CASE #21-DDP-0116  
WM #12382 / 21 1206

CONCRETE  
SUNSHINE CONCRETE

SITE LAYOUT PLAN  
JOB NO. 21218  
SHEET 1 OF 1

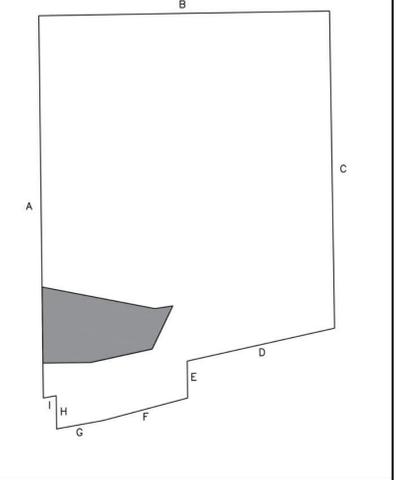
Overall, there is a complete lack of dimensions shown on this plan. There are no dimensions shown for buildings, fuel station, aggregate storage bins, or truck wash out from any property lines. The DDP application requires Building Setbacks with Dimensions as well as typical dimensions of parking spaces and aisles.

There are no renderings showing the views for all sides of the buildings, nor any elevations showing the silos and actual concrete mixing plant.

The berm proposed on the east of entry drive is not wide enough as shown to even be 6' height assuming a 3:1 max slope.

The entry drive has no indication that it will be a solid paved roadway. It shows a 24' dimension but no callout to paving type other than the screened back survey below that shows gravel on both sides of the narrow concrete strip. If this road remains gravel it will be a major source of dust contribution.

How tall are these storage areas. They should likely require elevations to be submitted as well.

No renderings or elevations were submitted for the actual concrete plant structures and silos. These are major structures on the site and should require elevations as well. The District Development Plan application requires "One set of renderings of the buildings proposed for the site. The rendering must contain ALL sides of building."

No renderings were submitted with the revised plan to show what this building is. The District Development Plan application requires "One set of renderings of the buildings proposed for the site. The rendering must contain ALL sides of building."

No renderings were submitted with any of the submittals. A picture of a warehouse located at 1103 Spencer Hollow Way was submitted. The District Development Plan application requires "One set of renderings of the buildings proposed for the site. The rendering must contain ALL sides of building."

Berm will need to be planted with mature plantings. A mix of deciduous trees and evergreen trees should be utilized. Trees should be installed with a minimum height of 15'. Trees should be triangulated on the berm to provide a contiguous screen. A row of trees at 30' on center at 1 3/4" caliper size will do nothing to stop dust and/or provide screening. A hardy evergreen hedge should be placed on the top of the berm. This hedge should be able to grow to 10'. This entire area around the concrete silo/plant should be considered vehicular use area as trucks will be driving around this entire area.

Providing a wheel wash system at this location would help to reduce dust and keep contaminants on the subject property. This can be accomplished by a simple 6'-6" wide water filled trough that tires have a full rotation through upon exiting the yard.

Berm will need to be planted with mature plantings. A mix of deciduous trees and evergreen trees should be utilized. Trees should be installed with a minimum height of 15'. Trees should be triangulated on the berm to provide a contiguous screen. A row of trees at 30' on center at 1 3/4" caliper size will do nothing to stop dust and/or provide screening (per previous condition of approval #7. A hardy evergreen hedge should be placed on the top of the berm. This hedge should be able to grow to 10'. This entire area around the concrete silo/plant should be considered vehicular use area as trucks will be driving around this entire area.

A 6' ft berm WILL NOT fit in this 28' +/- dimension. Assume max of 3:1 slope.

This entire 24' needs to be called out as concrete. There is a 24' dimension at the Aiken entry but it does not specify that the whole road will be concrete.
